Dear editor and reviewers, thank you for taking the time to examine our work. Several weak points were pointed out, which we hope to have comprehensively answered in the final version. Please find our answer (in bold blue) to the reviewers comments (in black).

In the manuscript the authors study the development of a wind turbine wake is studied in a moving reference frame. To be specific, the mean velocity and turbulence in the fixed field of reference are broken down into different terms, which are analyzed in the moving reference frame. In the present work the authors show that including the cross-terms improves the results. The effect of the cross terms is relatively modest given that analytical wake models generally have various simplifications. It is argued that this analysis is relevant to extend models like the DWM, which is submitted as a second paper, but not discussed here. Overall, such modeling efforts are relevant for the community to get improved insights. In any case the presented analysis does provide additional insights into the development of a wake. Although the statistical convergence of the data seems limited and uncertainty analysis is limited. These aspects

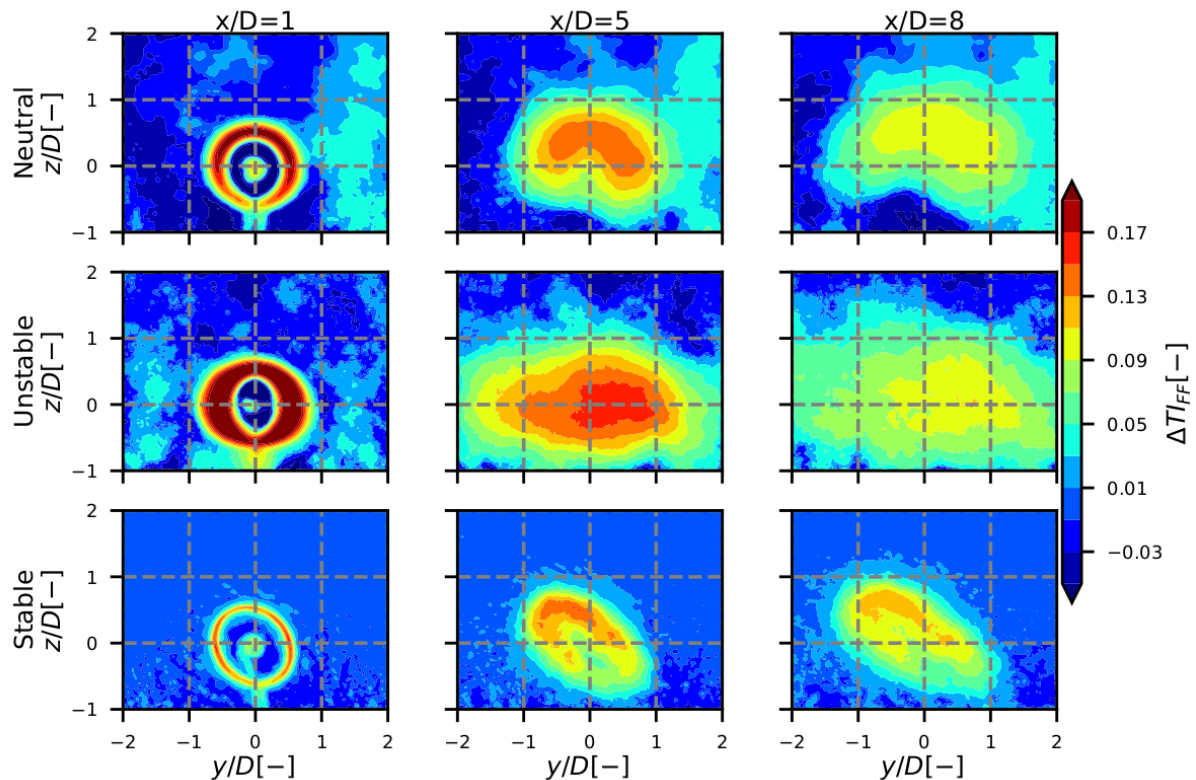
- Figure 12: How does the rotor added turbulence in the moving reference frame compare to what you would get in the fixed reference frame. What is your uncertainty in these results? There namely seems to be significant rotor added turbulence outside the wake.

The same graph, as Fig. 12 for the FFOR is displayed below. One can see that the shapes of the field are much more different between the different cases than in the MFOR. About the rotor added turbulence outside the wake (for instance on the right of the neutral case), this appears in both frames of

reference, and is here attributed to a more energetic ABL eddy located at this position in the turbine simulation compared to the reference simulation. Once again, we think that an ensemble average of several datasets could improve these results, but we did not quantify the related uncertainty.

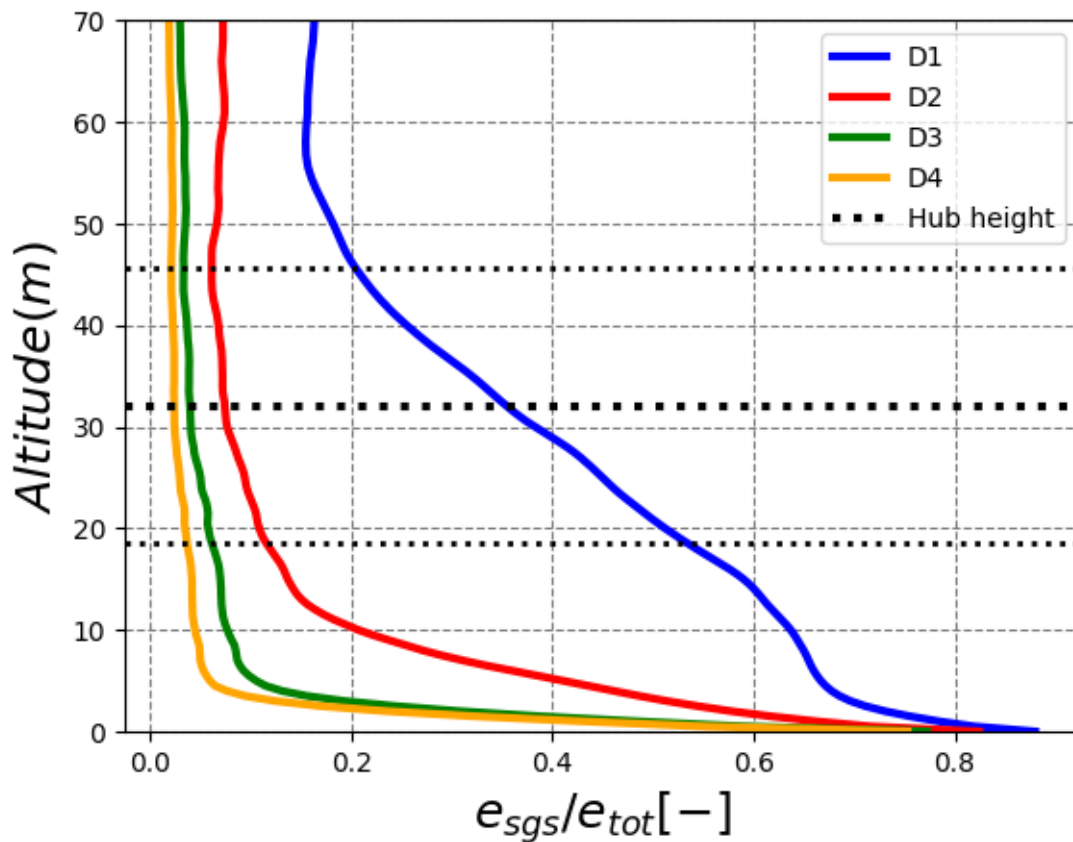
Lines 225-229 – More information needs to be included on how the contributions of sub-grid scales are quantified and in turn negligible as the authors suggest.

A 1.5-order closure is used in Meso-Nh to compute the subgrid fluxes: the subgrid TKE is a prognostic variable likely to u, v, w or θ. We can thus compute a ratio between the subgrid TKE and the total TKE (i.e. subgrid + variances of u, v and w). Averaged on each level of the domain, it gives distributions like in the figure below for the different nested domains (here for the neutral case). Note that only domain D4 (orange) is of interest, as the other domains serve only to generate realistic boundary conditions for D4. In the figure (neutral case), except near the ground, the subgrid TKE is about 2-5% of the total TKE. In the unstable case, it is even less (because there is a lot of large-scale

turbulence) but in the stable case, results are not so good due to the absence of large-scale turbulence, and the subgrid TKE can reach more than 20% (and not 10% as firstly indicated) of the total turbulence.

"Since subgrid turbulence is a prognostic variable in the 1.5-order closure used in Meso-NH, one can compute the ratio between subgrid and total turbulence. It is between 1 % and 5% in the neutral and unstable case but can reach more than 20 % in the stable case. This highlights the difficulty of simulating strongly stratified ABL, but our results have been successfully compared to the SWiFT benchmark (Jézéquel et al., 2021), so they will be used nonetheless "

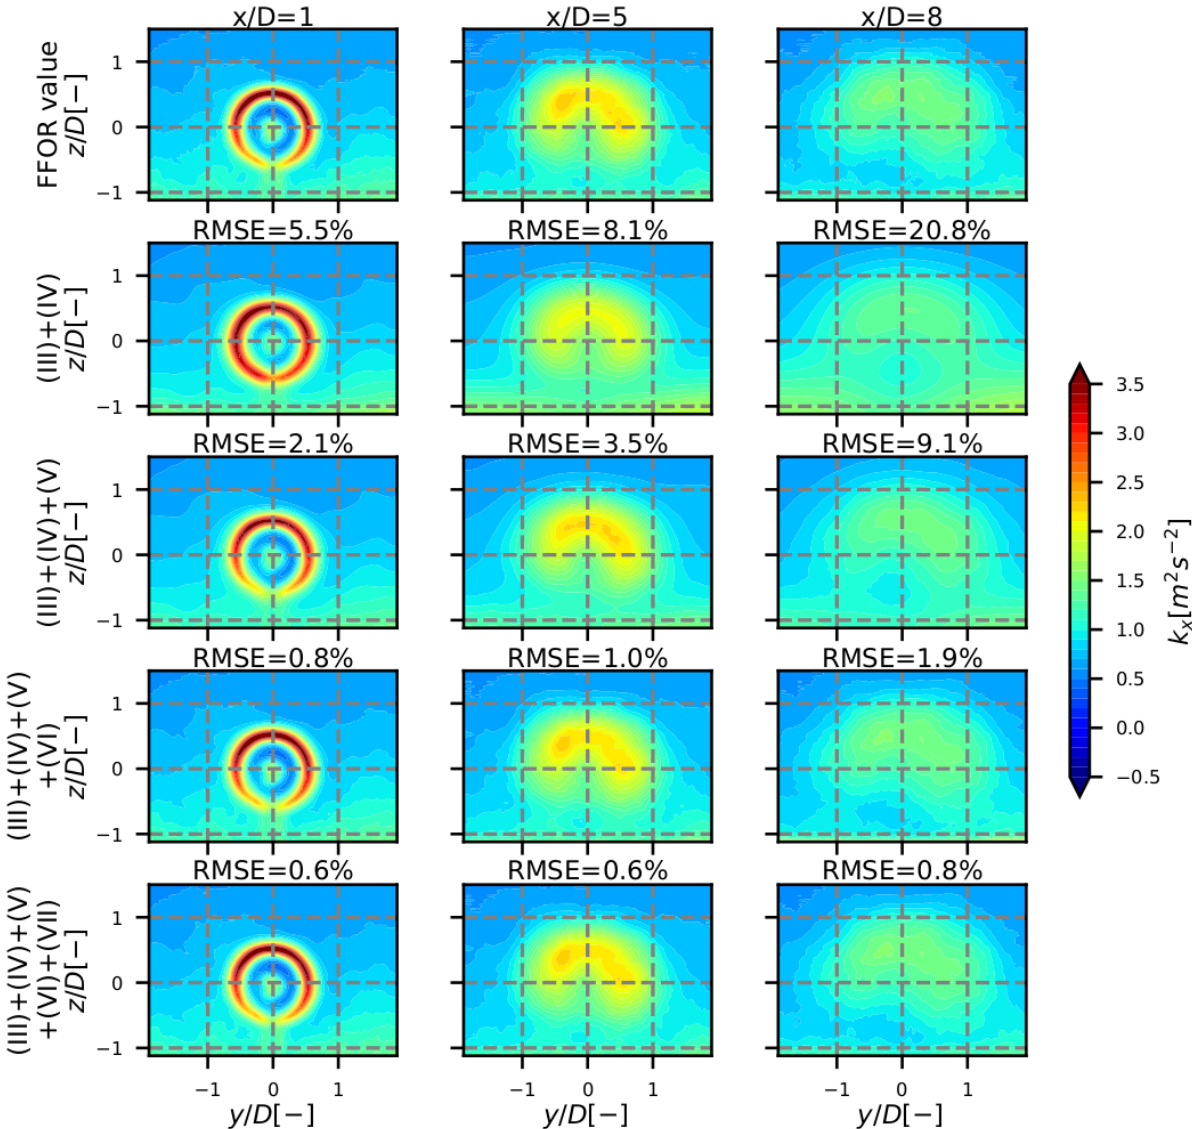
Figure 7 shows the RSME of the maximum axial turbulence, is there an explanation for the max RSME value to be at x/D = 5 for the neutral case (is it also observed in other cases)? Also, no quantitative information is provided for the other two stability cases, only trends of the data and order of magnitude.

In the unstable case, a similar maximum error appears at 6D and then the error of (III)+(IV) decreases. To the authors' interpretation, this comes from an error compensation, combined with the fact that in the far wake $k_{x,LES}^{M}$ is low and thus the computed value is very sensitive to small changes. The authors hesitated to display the following figure instead of Fig. 7, where it can be easier to understand what happens as the different terms are added, but is a bit redundant with Fig. 6, takes more place and is more qualitative. On this graph we see that at x/D=8, the maximum TKE of (III)+(IV) in the restricted area ([-2D,2D],[-1D,1D]) is at the bottom of the domain due to edge effects. This decrease of error observed in Fig.7 is thus attributed to edge effects rather than actual better performance.

"In the far wake (beyond $x/D=5$) the error decrease but this is a numerical artefact: due to edge effects, large TKE values are observed near the ground, and thus the maximum TKE is detected at this location instead of at the top tip."
